Avalon Ft Greene

Avalon Fort Greene FCE elec vs Rating

Avalon Fort Greene Total Energy Balance vs Rating

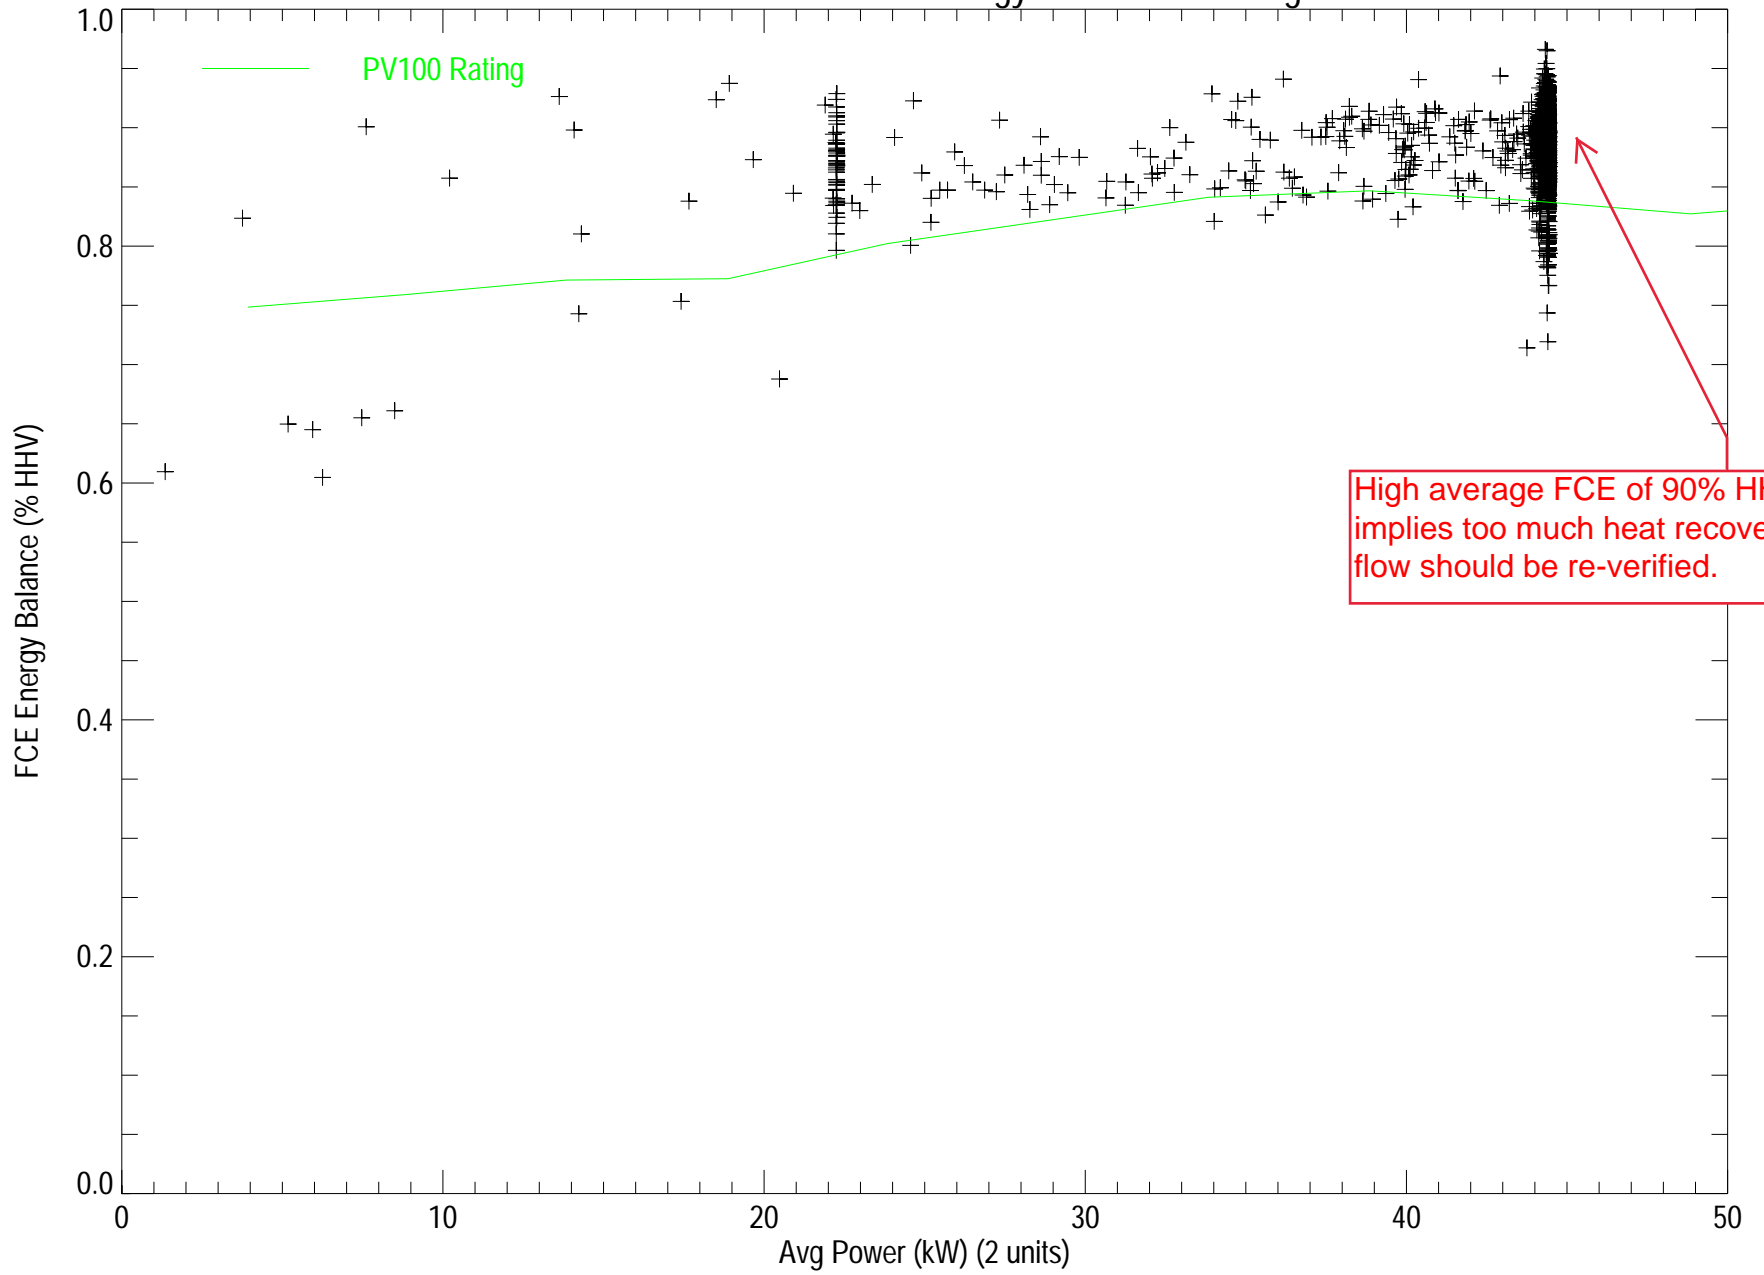
High average FCE of 90% HHV implies too much heat recovery - flow should be re-verified.
